WARNER PATH RECONSTRUCTION AND BRIDGE REPLACEMENTS

As of March 13, 2013

SUMMARY OF PUBLIC COMMENTS TO DATE

WARNER PARK PATHS
BRIDGE REPLACEMENT
AND SHELTER AREA DETAIL

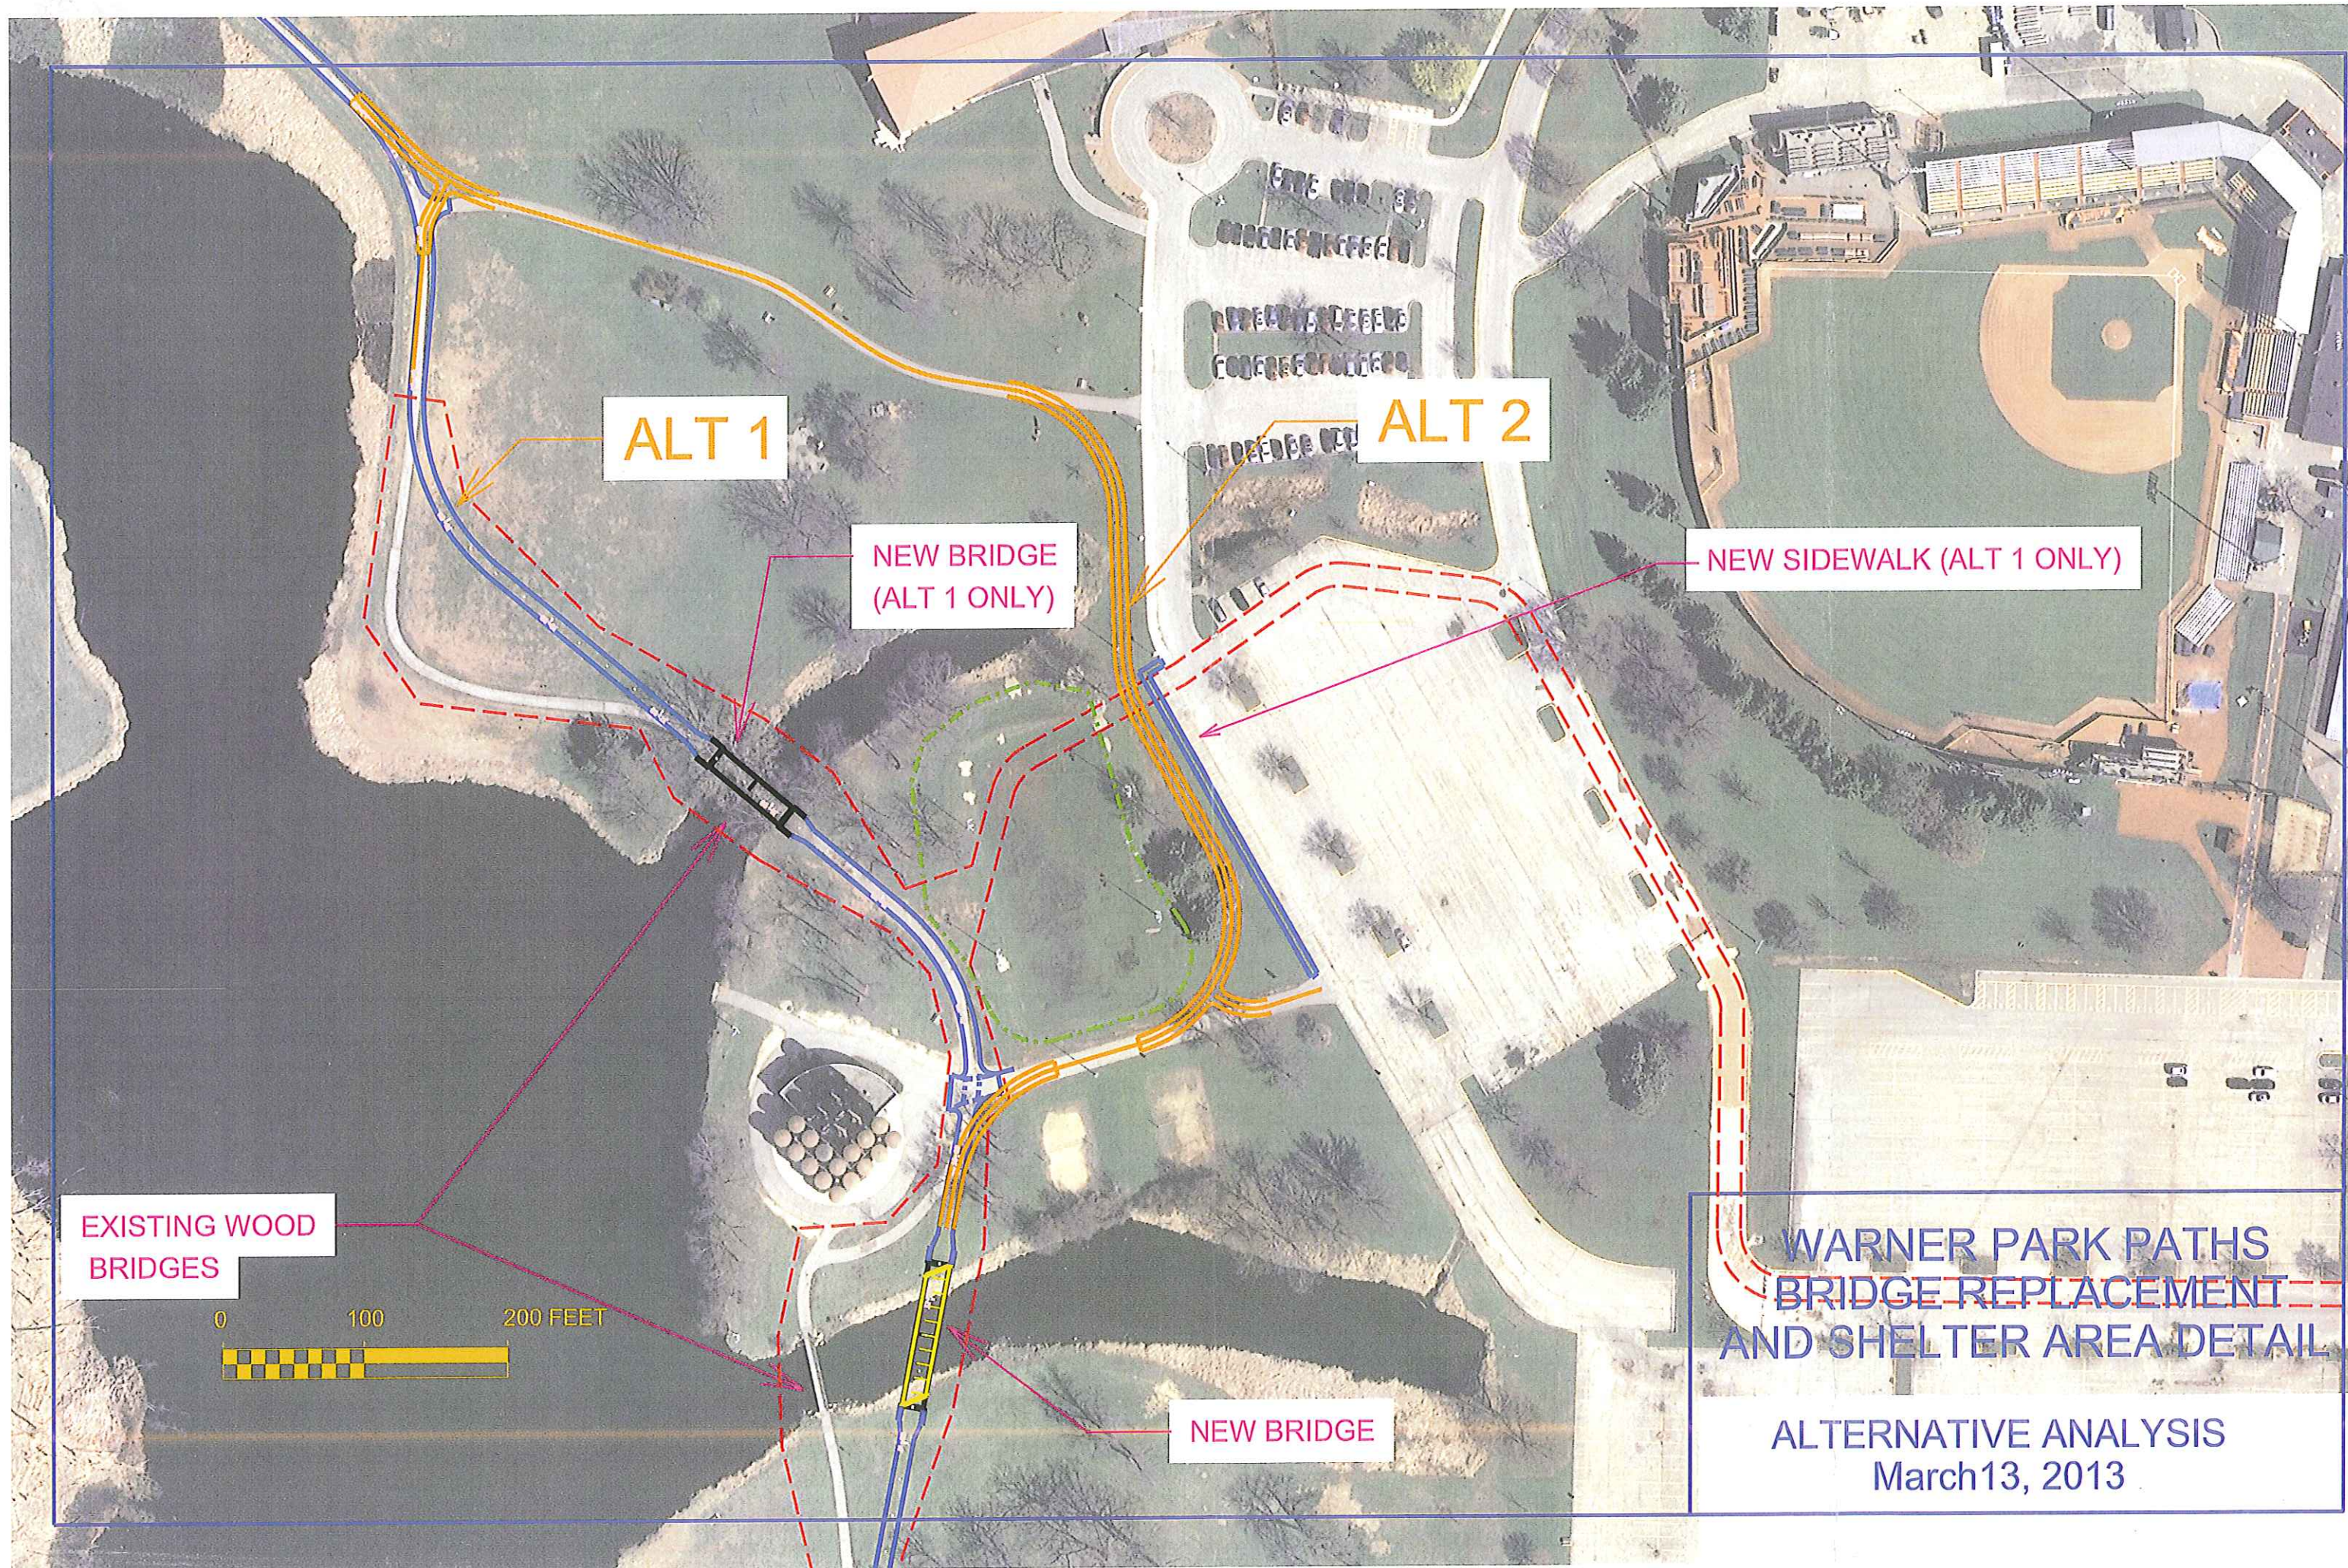
- Protection of the existing wooden bridges and trees.
- The lack of a dedicated pedestrian route between the shelter and the community center.
- Increasing the path width / impervious area in the park.
- Minimizing conflicts between pedestrians and bikes.
- The need to dredge the inlets to improve fish habitat.

- Leaving the south bridge in place as a dedicated pedestrian route.
- Routing the bike path around the northern inlet area to provide a route between the shelter and the community center and also preserve the existing north bridge.
- Preserve the existing character of the park by locating the path close to the lagoon.

This alternative adds the greatest distance (around 290 feet of asphalt path) to the route for bicyclists or others using the path for transportation. Since it also leaves the existing path and bridges in place it raises greater concern that some bicyclists will continue to use the shorter (and more scenic) route, creating redundant facilities and diminishing the value of the improvement. It significantly increases the total impervious area in the park by about 10,000 SF or 33% more than Alternate 1. It generally skirts the activity area near the rink with most bicycle traffic, though it subsequently reduces this open area somewhat and provides a potential conflict between pedestrians moving from activities in the open area to the parking lot. It also would route commuter bike traffic through the main activity area for the community center immediately southwest of the building.

It would complete a hard surface route for pedestrians between the shelter and the community center on new path, addressing a neighborhood concern but to some extent making a segment of existing sidewalk redundant. It appears to not require additional tree removals in the area near the rink area, but this has not been fully evaluated.

Alternative 1 is the original proposal for the Warner Path Reconstruction and Bridge Replacements project as shown in the materials that have been posted on the website. This alternative provides a significantly more direct route for bicyclists and others using the path for transportation. Alternate 1 includes the removal of both wooden bridges due to their deteriorated condition and one large tree (40-inch cottonwood) growing around one of the bridge abutments; potentially 2-3 small cottonwood trees may need to be removed as well. It provides a better aesthetic experience for bicyclists and pedestrians as it continues to use the existing route adjacent to the lagoons.

It increases the total impervious area in the park by about 7500 SF, mainly due to the change in width from 8' to 10' wide. (See Table 1 for a summary of lengths, areas and costs of the two alternatives). The route utilizes the existing path alignment east of the shelter and reduces the bike path traffic directly to the shelter, without limiting access to the shelter. Alternate 1 would also include the installation of a sidewalk for pedestrians between the shelter and the community center, along the parking lot, and shifting the path closer to the lagoon on the northern segment, both to address neighborhood concerns that were raised through the public input process.

Initial construction costs (from Engineering budget) would be about \$124,500 less than Alternate 1, primarily by eliminating a need for a new north bridge. However, it would require Parks to maintain, repair and eventually replace the existing north bridge, partially if not entirely offsetting the savings in the long run.

WARNER PARK PATHS
AND BRIDGE REPLACEMENT
CONCEPT PLAN FEBRUARY 2013

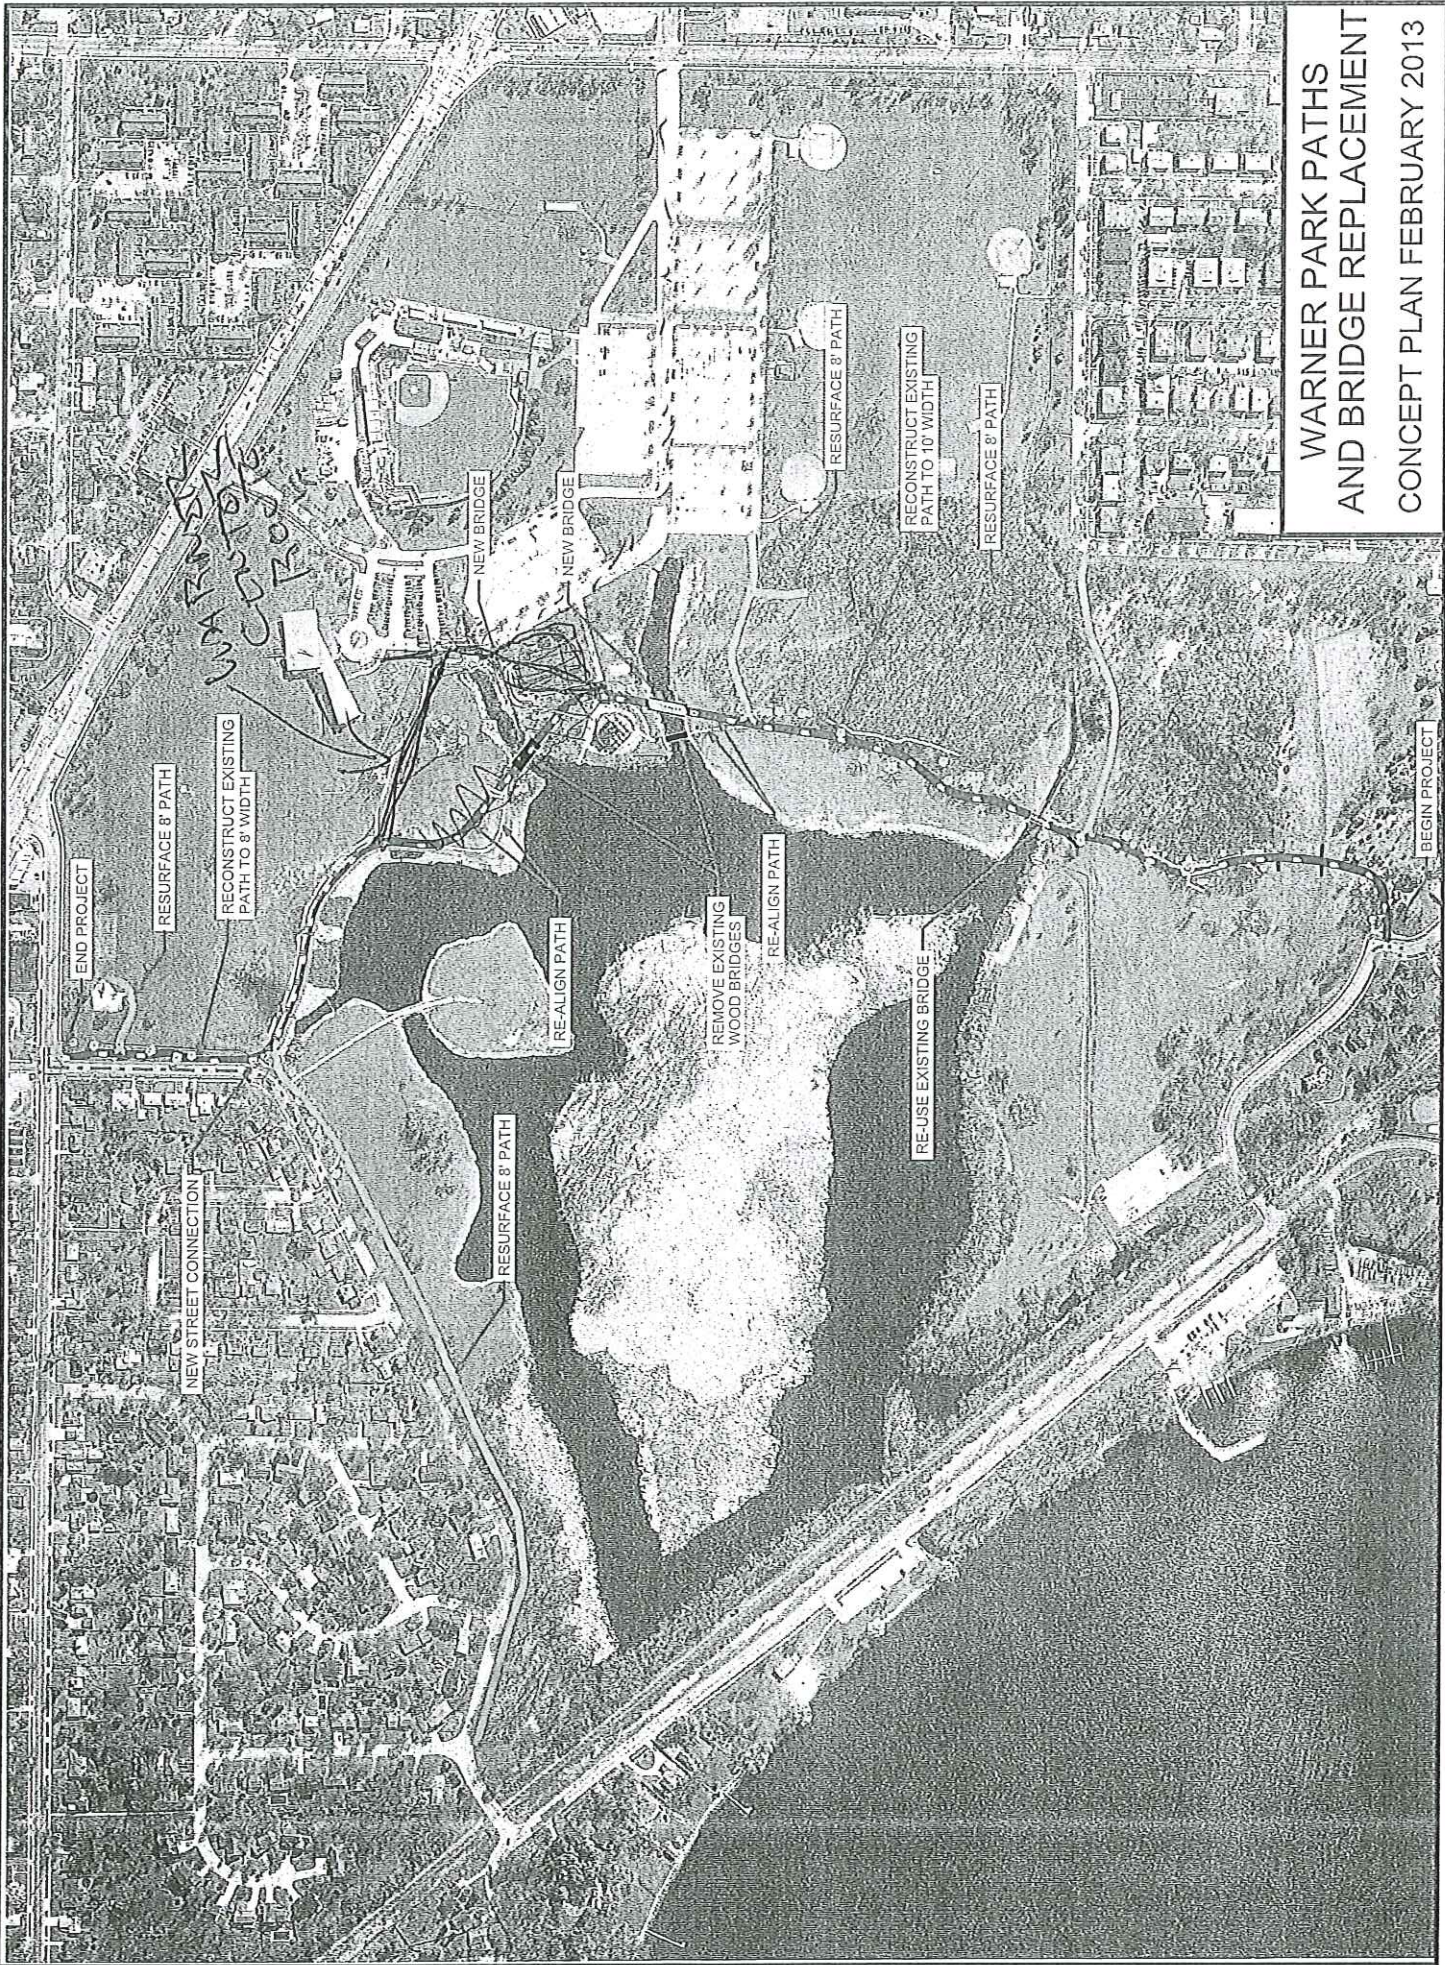
PLEASE USE THE EXISTING

PATH THAT GOES BY

WARNER CENTER, TURN

70° AND GO STRAIGHT

TO TIN CAN SHELTER

AREA & NEW BRIDGE

- CHEAPER BY \$100K (USE FOR MAINT)

- GREAT ACCESS FROM

WARNER CENTER FOR MIXED USE / HANDICAP / EVENTS

- PRESERVES BOTH SCENIC WALK ARCH

- MORE DIRECT FOR BIKES COMING/GOING
TO N SHERMAN AND TO FLYER ROUTE

- MORE SPACE FOR AUDUBON ART FAIR
(& EASY ACCESS) AND OTHER EVENTS AT CENTER
OUTDOORS
